# Analysis of Proposed Changes to the Cedar LNG Project

FINAL REPORT

May 2025

**FIGURE 1. CEDAR LNG PROJECT FACILITY AND MARINE TERMINAL AREA, TRANSMISSION LINE CORRIDOR, ALTERNATIVE TRANSMISSION LINE CORRIDOR AND DISTRIBUTION POWERLINE**

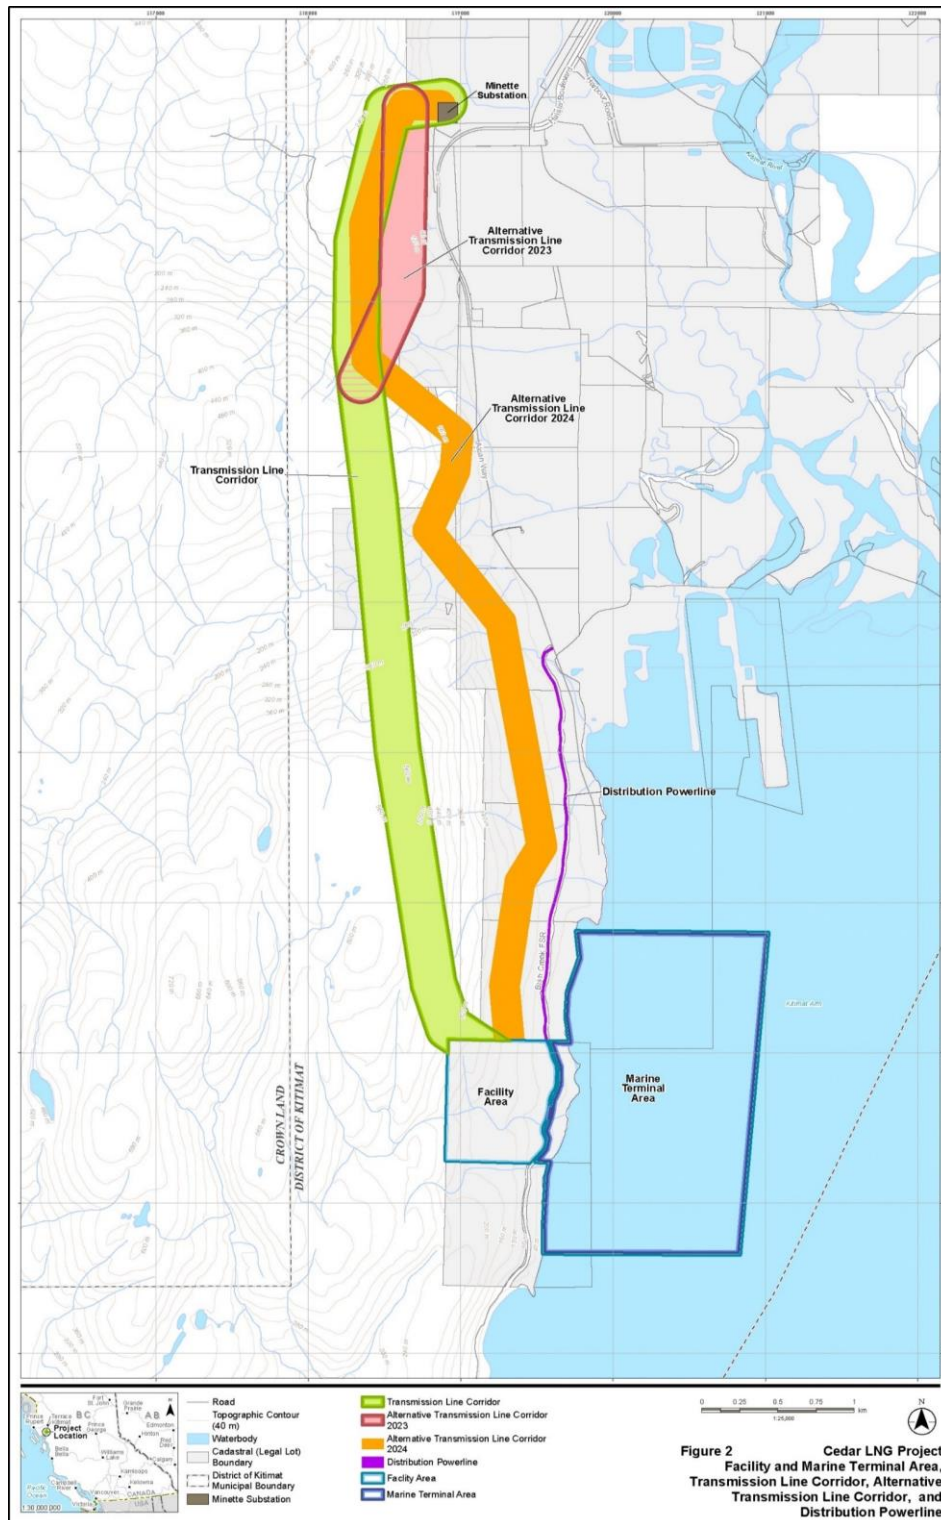
- Add a new 2.8 km long, 25 kilovolts (kV) distribution powerline, along the Bish Creek Forest Service Road (FSR) to the Marine Terminal Area.
- Add an alternative 8.5 km long 287 kV transmission line route option between the Minette BC Hydro Substation and the Marine Terminal Area (identified as the Transmission Line Corridor 2024 on Figure 1 below):

- relocated downslope toward Douglas Channel (a shift from Crown to private land);
  - with an increased right of way from 45 m to 90 m to accommodate safety and operability requirements;

- that results in increased clearing from 32.5 ha to 69 ha; and
  - with a reduced width of permitting corridor from 300 m to 200 m.

FIGURE 2. CEDAR LNG PROJECT AMENDMENT

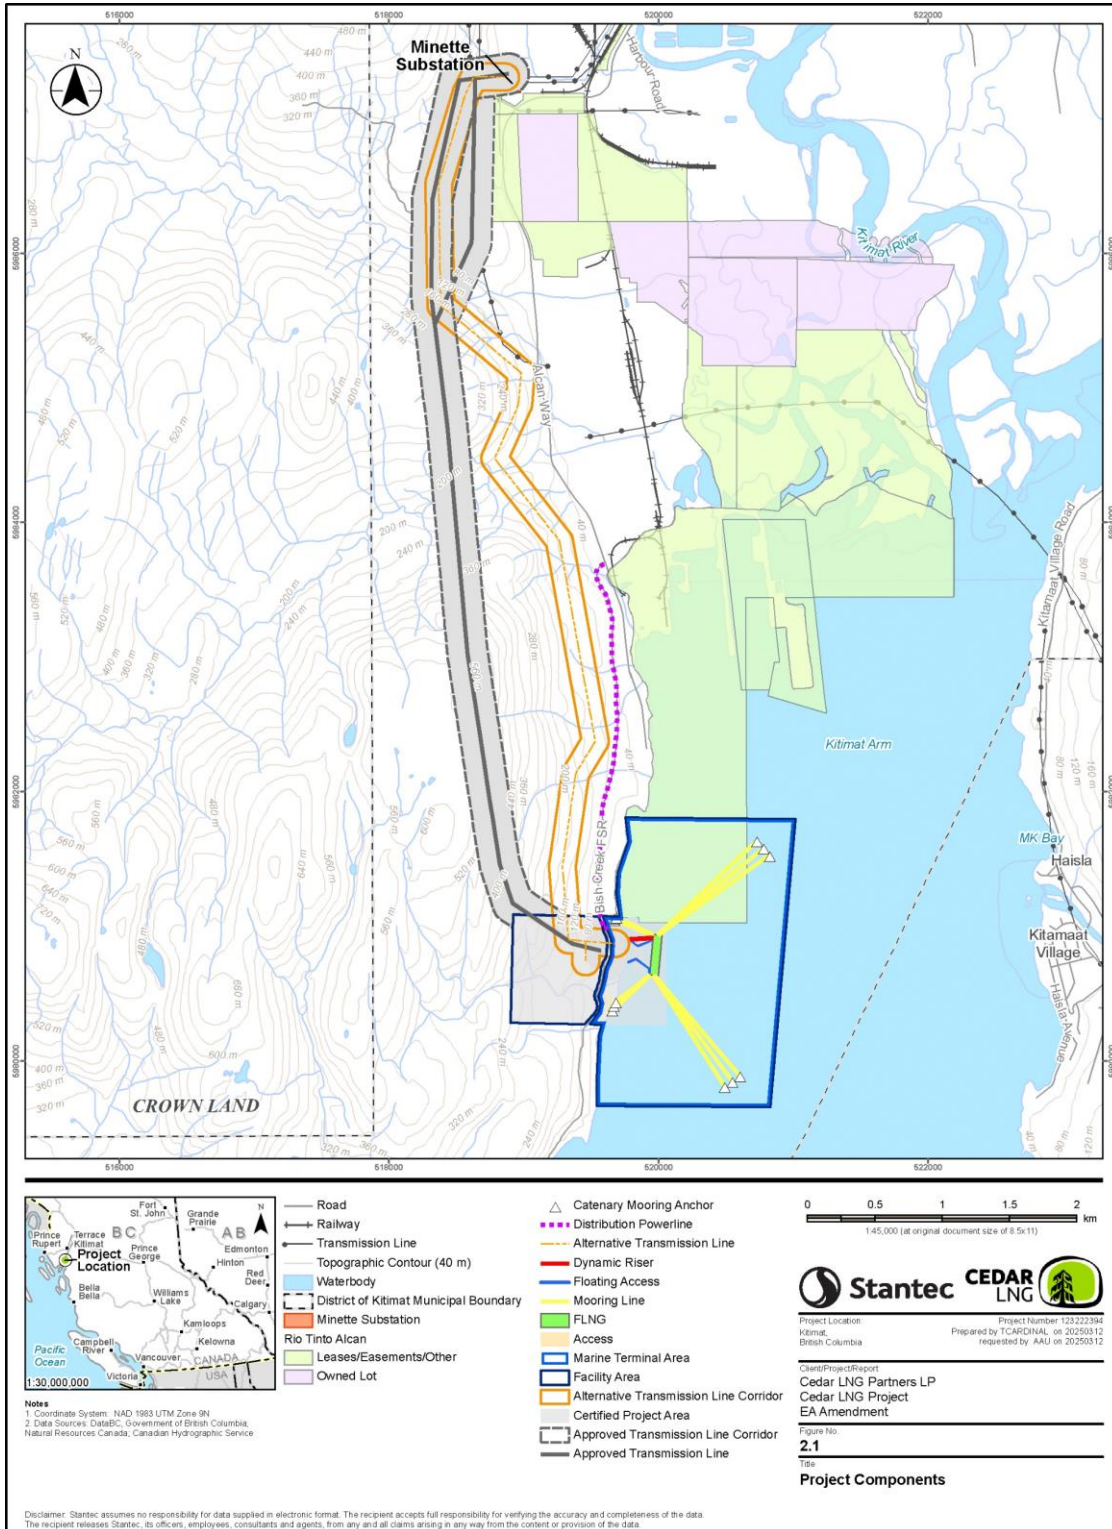
- Expand the Marine Terminal Area from 35.8 ha to 277.3 ha to encompass the mooring lines and anchors for the floating liquefied natural gas (FLNG) facility's catenary mooring system. The increase in hectares (ha) represents the area covered by the submerged mooring lines as shown on Figure 2. The installation of the mooring system will cover approximately 0.09 ha of seabed. No change will occur for the land-based portion of the Facility Area.
